Manor Farm, Emsworth

Highways and Transport Technical Note

For Farm Access to Land East of Manor Farm Close, Denvilles,
Emsworth

Title	Details
Project	Manor Farm, Emsworth
Report Title	Transport and Highways Technical Note for Farm Access
Report Reference	107818-PF-C-ZZ-XX-RPT-0002
Report Revision	P00
Date	23rd June 2023

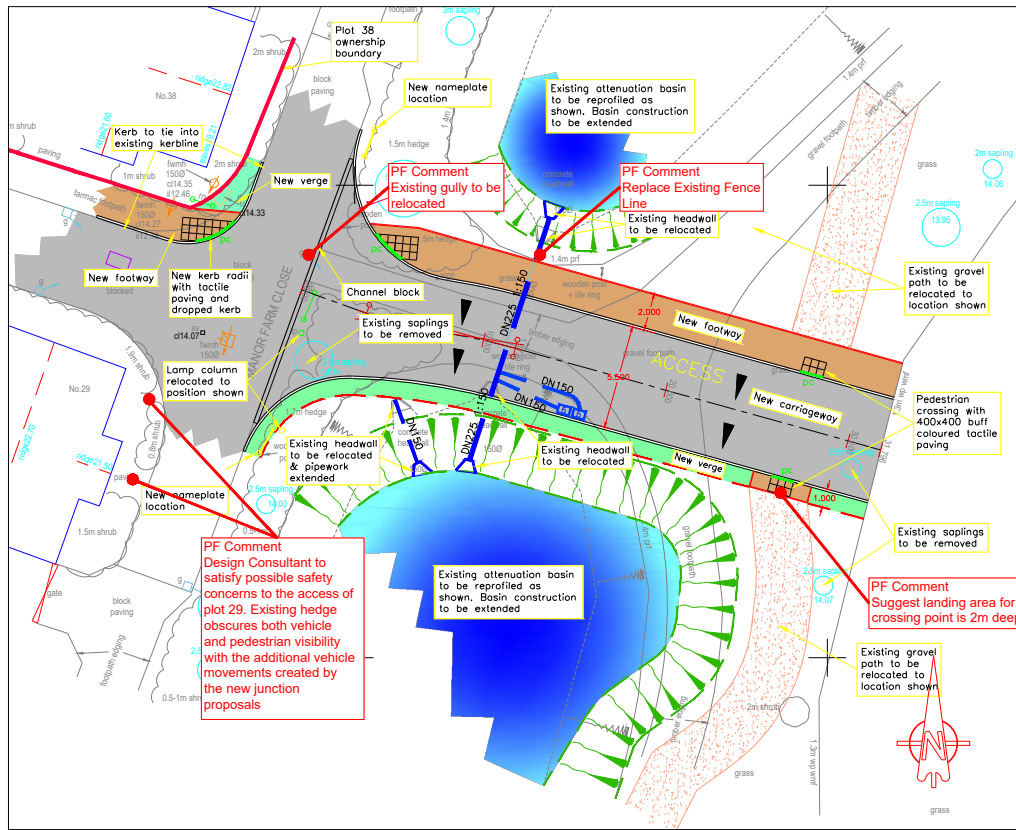
- 5.1.5 No details have been provided on the MJA Consultants drawings in relation to the proposed surfacing and carriageway/footway construction build up for the farm access. The current carriageway surfacing on Manor Farm Close in the vicinity of the proposed access is concrete block paving laid in a herringbone pattern with the footways in asphalt. Fifth Avenue approaching the new access is block paving and appears 'in keeping' with the design ethos of the existing development and is used in many areas. The use of blocked paved roads is as described in Hampshire County Council Companion Document to Manual for Streets April 2010 section 3.26. Asphalt footway construction is as specified in section 3.36.2. However for the Farm access more traditional and hard wearing materials like 'Asphalt' may be more practical for this use.

- 5.1.6 Visibility splays are required for the junction in accordance with Table 7.1 of Manual for Streets. It is assumed that the existing development west of Manor Farm Close has a speed limit of 20 mph with Southleigh Road having a 30mph speed limit. Based on the Visibility Splays set out in Table 7.1 of MfS, Visibility Splays can be met, however existing planted landscaping north and south of the proposed junction may need to be trimmed down and maintained to maximum of 600mm in height.

- 5.1.11 Pedestrian routes as highlighted above are reflected in the new design with the continuation of the route from the north side of Fifth Avenue and the introduction of an uncontrolled crossing. There is however concern in terms of safety and visibility of pedestrians coming from or going to 29 Manor Farm Close. Specifically, an existing hedge obscures both vehicle and pedestrian visibility. This needs further consideration (possibly removal of the hedge) and an 'all access' safe waiting point introduced.

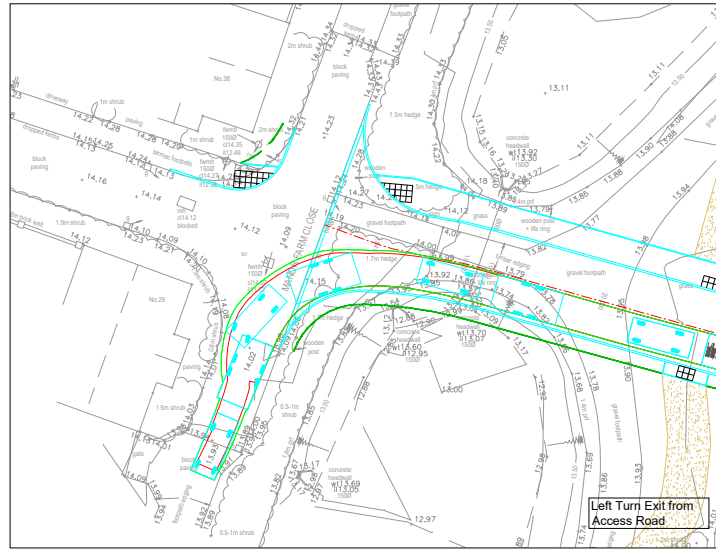
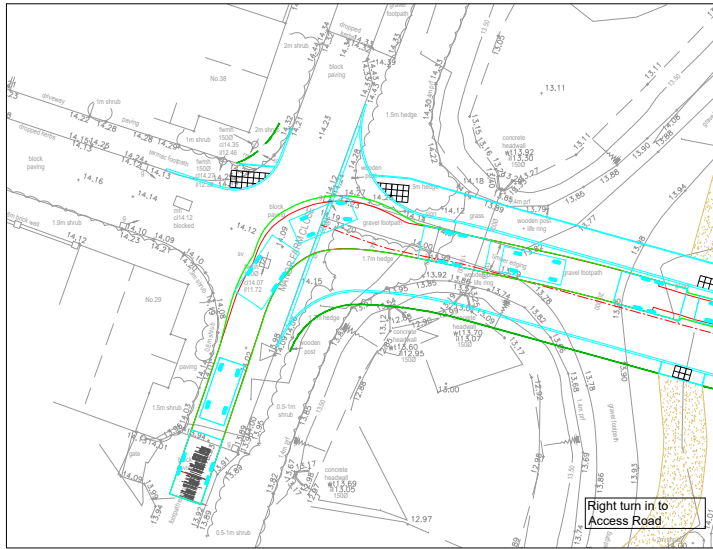
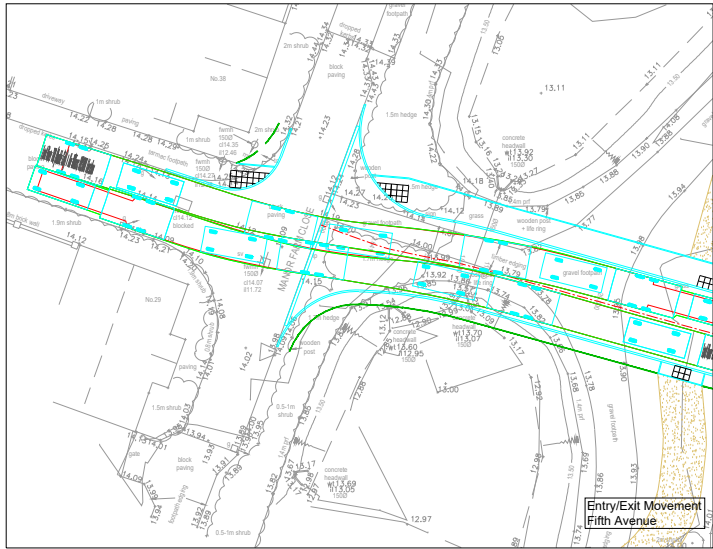
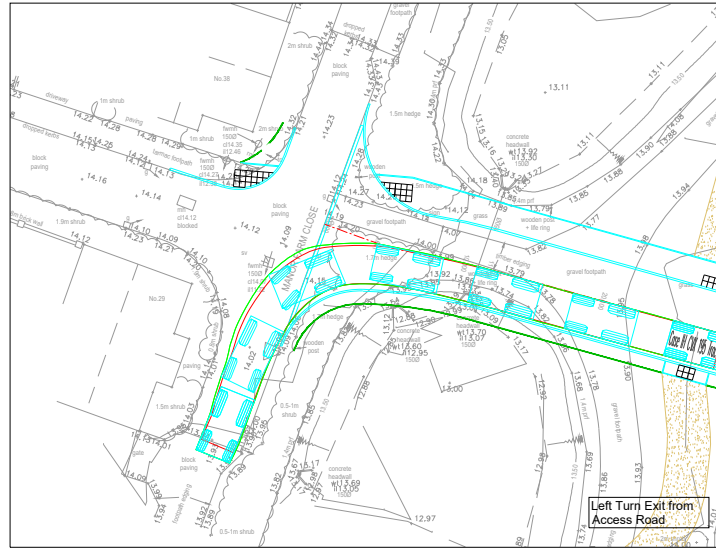
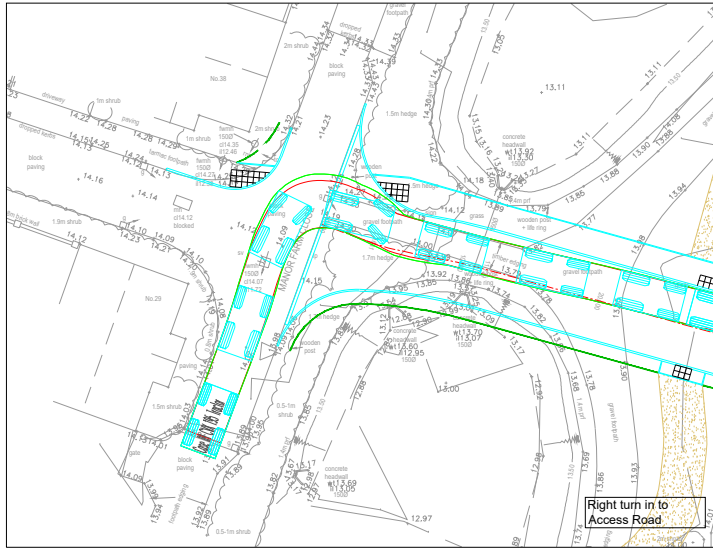
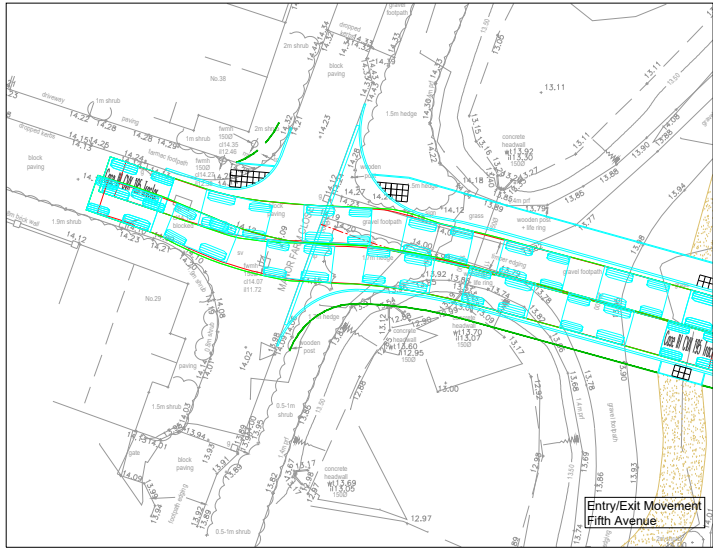
- Add Kerb Radii to access road
- Confirm Carriageway and Footway Construction Types
- Add junction visibility Splays in accordance with Table 7.1 Manual for Streets
